3948 Washington St., Kensington

HAWP Case #: 31/06-17H

MONTGOMERY COUNTY HISTORIC PRESERVATION COMMISSION
STAFF REPORT

Address:	3948 Washington St., Kensington	Meeting Date:	9/19/2017
Resource:	Outstanding (Primary One) Resource Kensington Historic District	Report Date:	9/12/2017
Applicant:	James Cooper	Public Notice:	9/5/2017
Review:	HAWP	Tax Credit:	Partial
Case Number:	31/06-17H	Staff:	Michael Kyne
PROPOSAL:	Handrailing installation and storm door replacement

COOPER RESIDENCE
PROPOSED STAIR RAIL

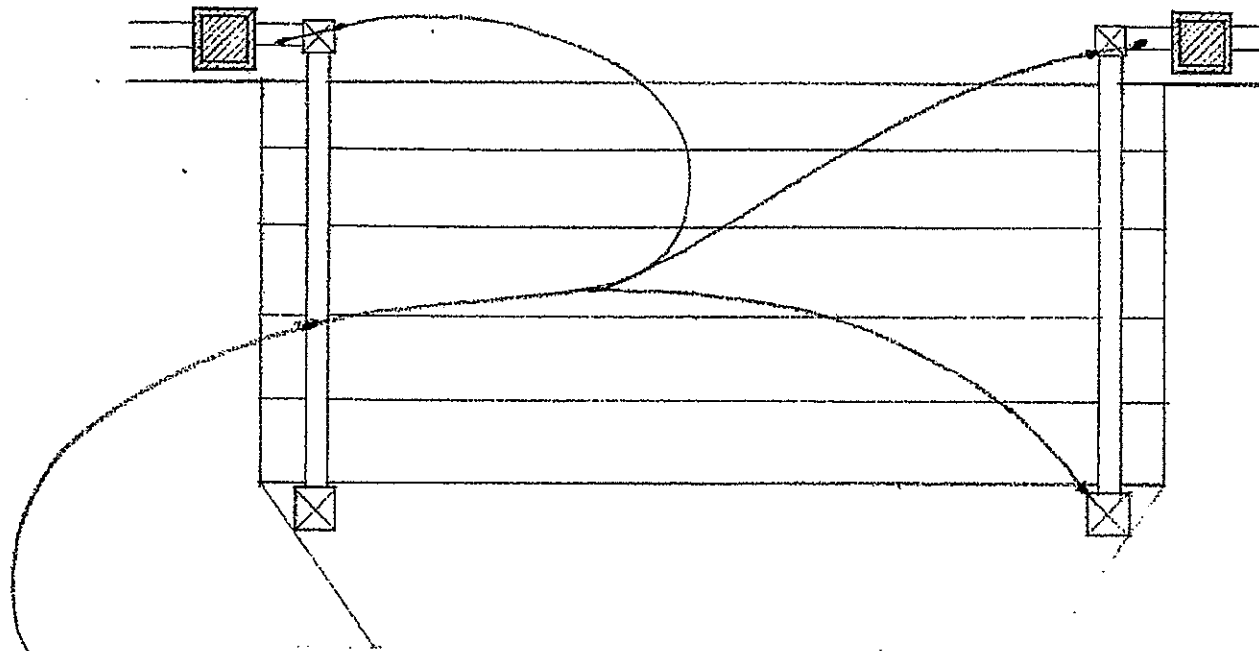
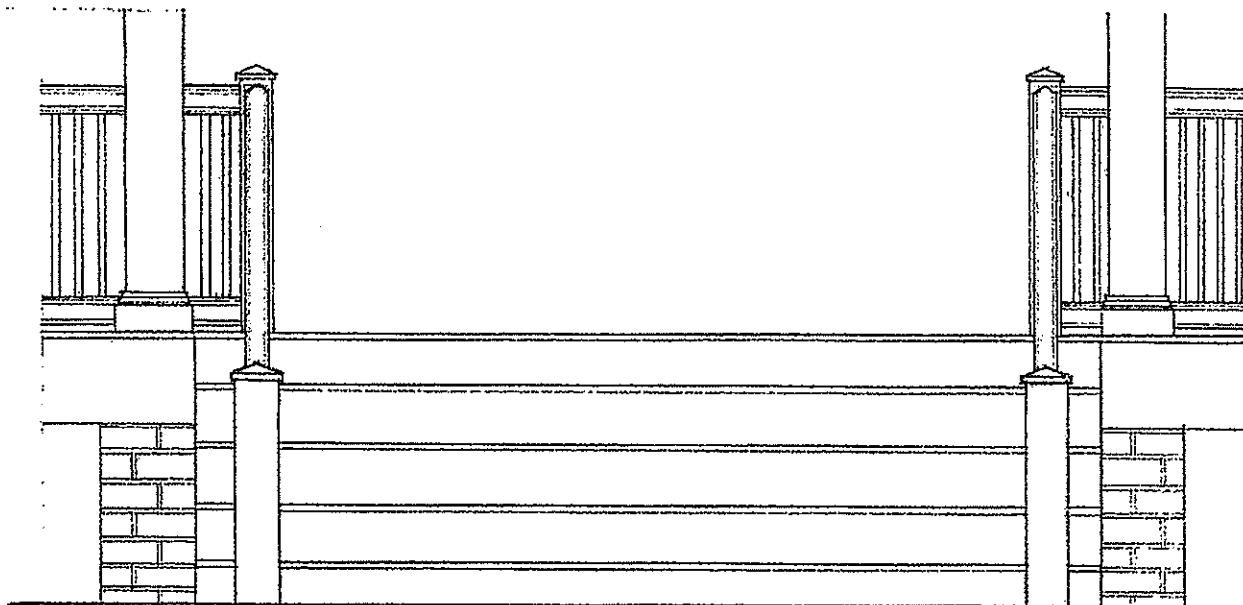
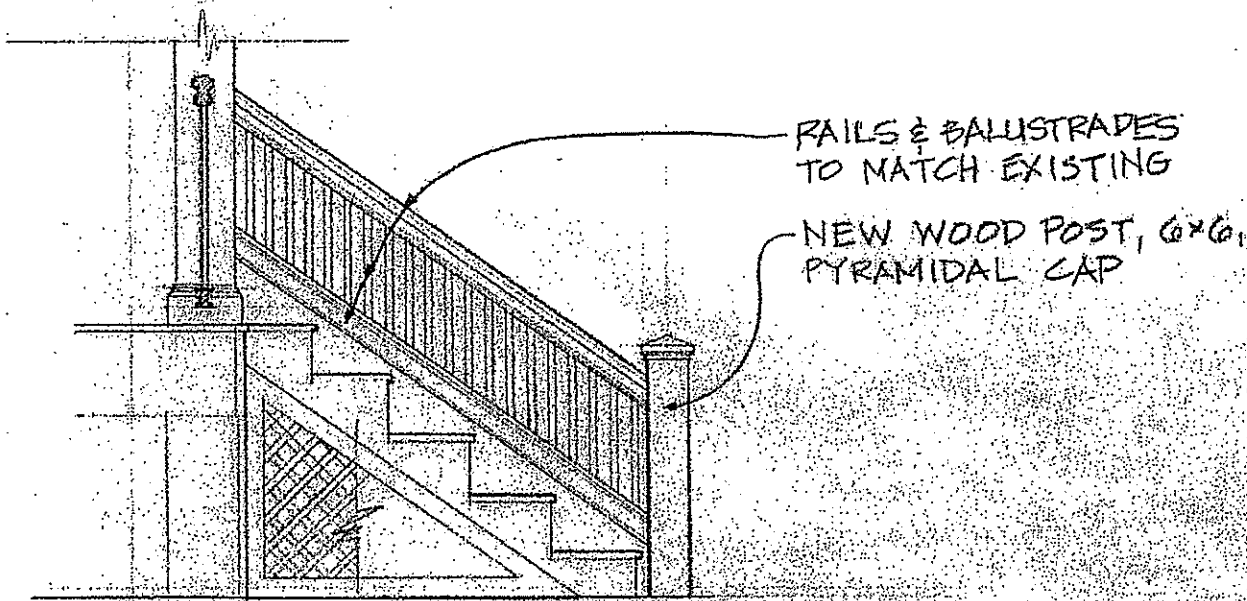
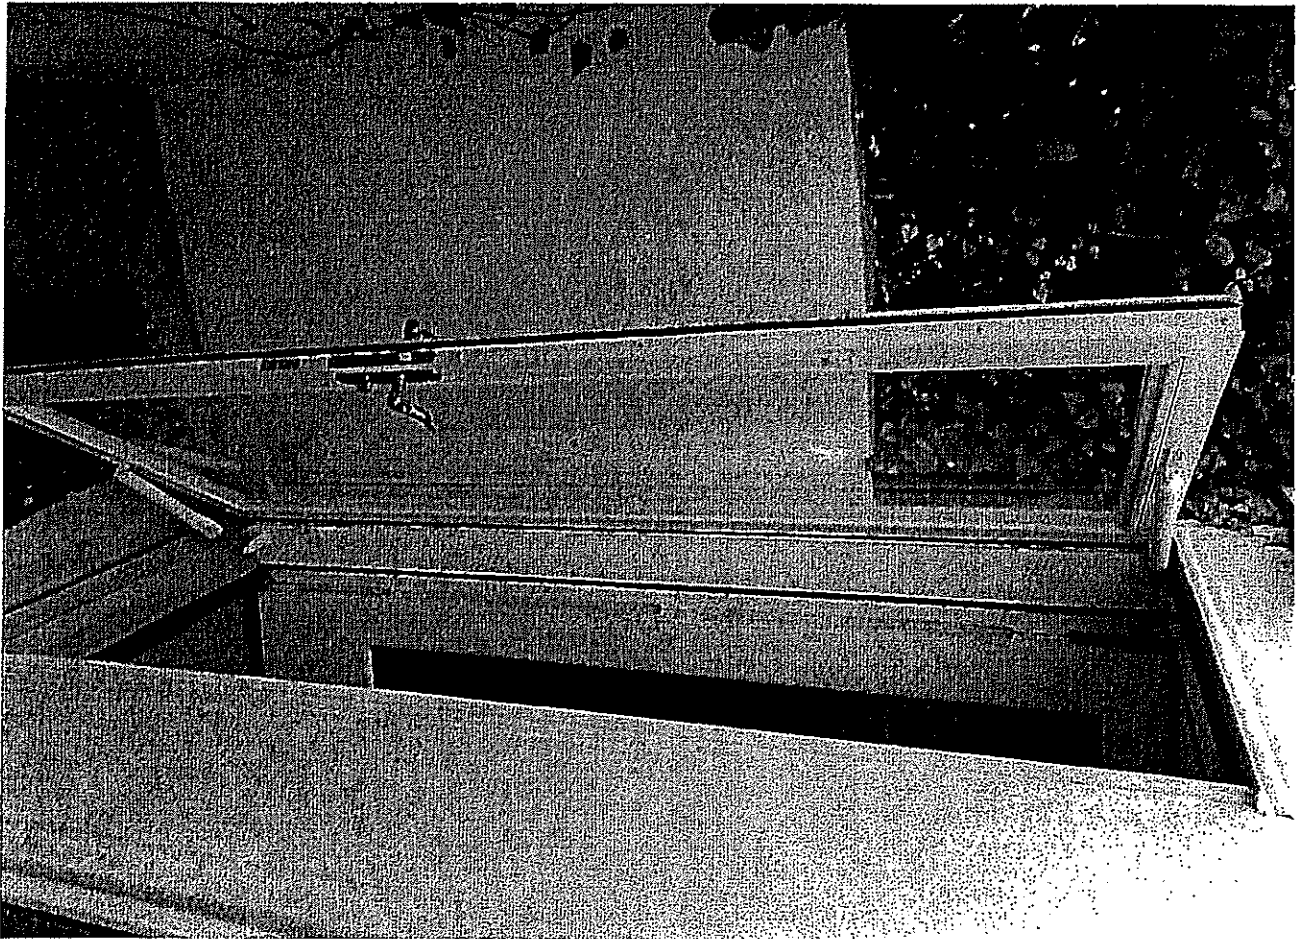
The applicant proposes to install wooden handrails on each side of the front porch steps, with details to match the existing porch railings. The existing front porch steps are not original to the house, but are in the original location/configuration. The applicants have indicated that there is no evidence that handrails previously existed at the front porch steps.

Standard #2 states that the “The removal of historic materials or alteration of features and spaces that characterize a property shall be avoided.” Due to its location and visual prominence, staff suggests that the front porch with central porch steps is a character-defining feature of the subject property. Because the proposed handrails will alter this character-defining feature, the proposal should be reviewed with greater scrutiny.

Standard #3 states that “Each property shall be recognized as a physical record of its time, place, and use. Changes that create a false sense of historical development, such as adding conjectural features or architectural elements from other buildings, shall not be undertaken.” While the handrails are compatible with the existing features and they are being proposed for safety purposes, there is a potential for handrails that match the porch railings to be misconstrued as original to the house.

In accordance with *Standard #9*, the proposed alteration should be differentiated from the original features to protect the historic integrity of the house and allow the original features to be discerned.

1. The front porch step handrails will be differentiated from the porch railings, with final review and approval delegated to staff.

Staff recommends a condition of approval, stipulating that the front porch step handrails will be differentiated from the porch railings, with final review and approval delegated to staff. Appropriate options might include simple black metal handrails that recede from view when viewing the house from the public right-of-way.

Replaced Andersen Storm door.

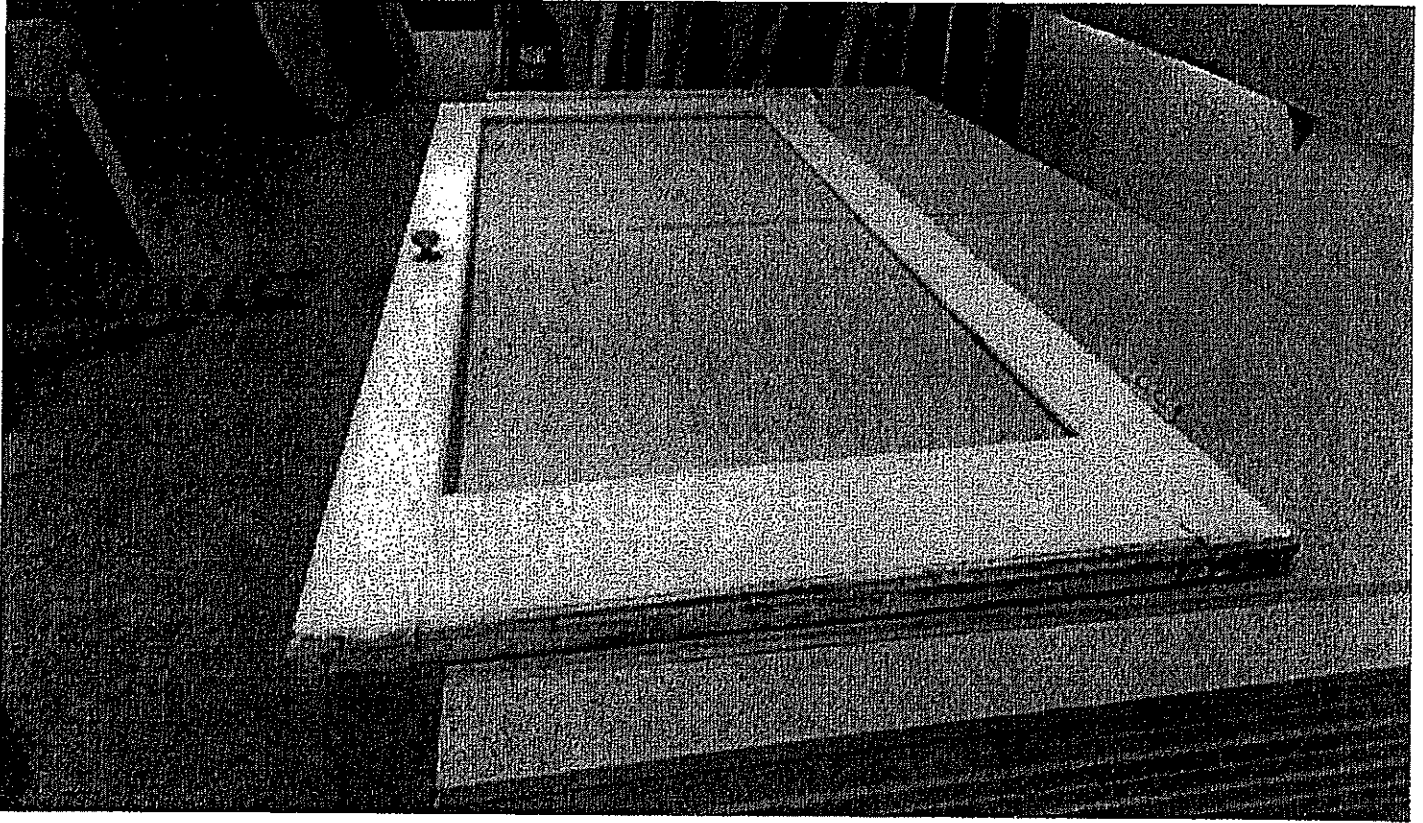
The applicant is seeking retroactive approval for the replacement of a non-historic basement-level storm door on the right side of the house. Because the storm door is non-historic, at the basement-level, and

toward the rear of a secondary elevation, its replacement should be reviewed with lenient scrutiny. Staff suggests that the proposal has negligible potential to alter features that characterize the property or to detract from the surrounding historic district.

B.3: Broken Storm door - South side

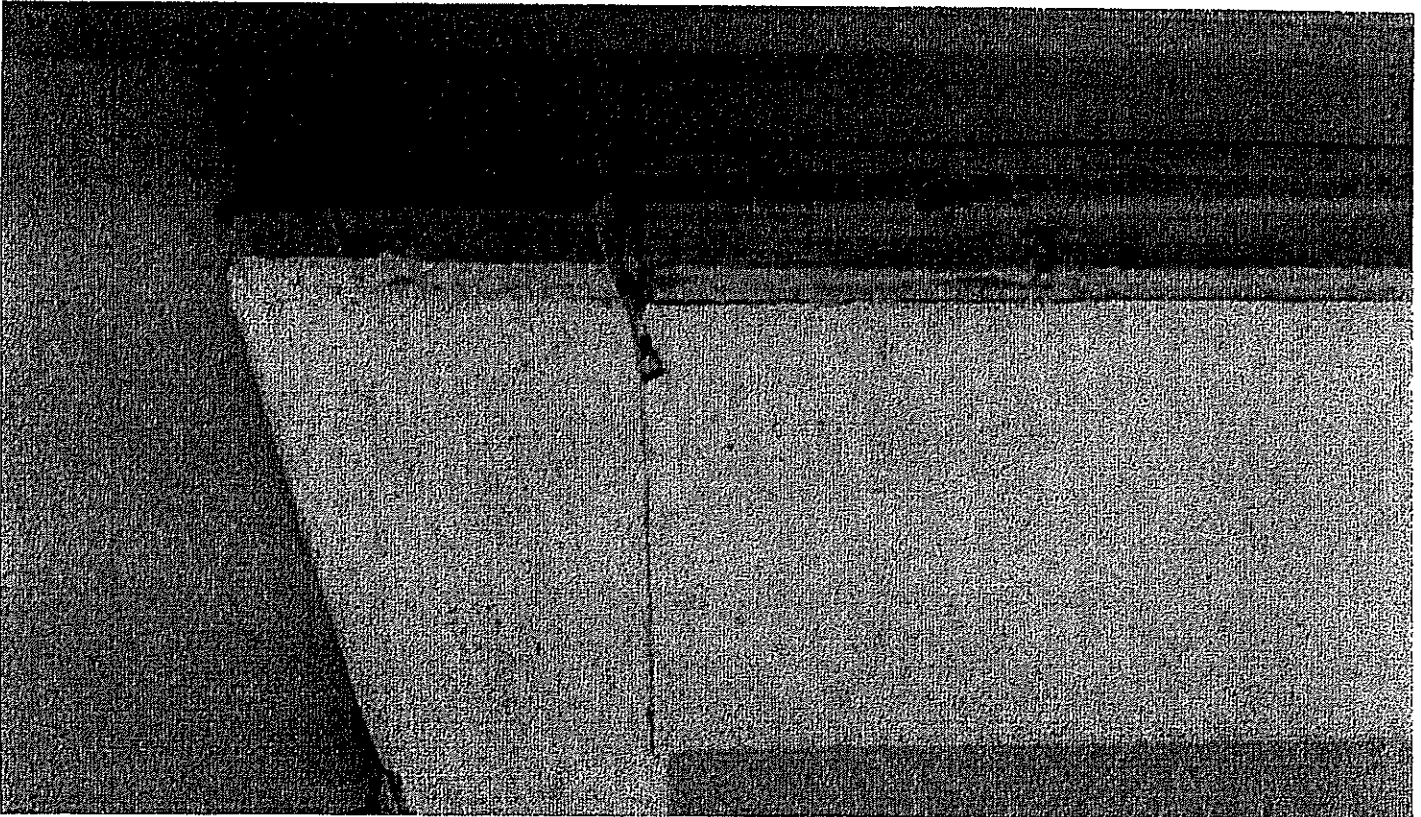
Staff supports the repair of the existing storm door on the left side of the house, as the proposal will result in no visual change.
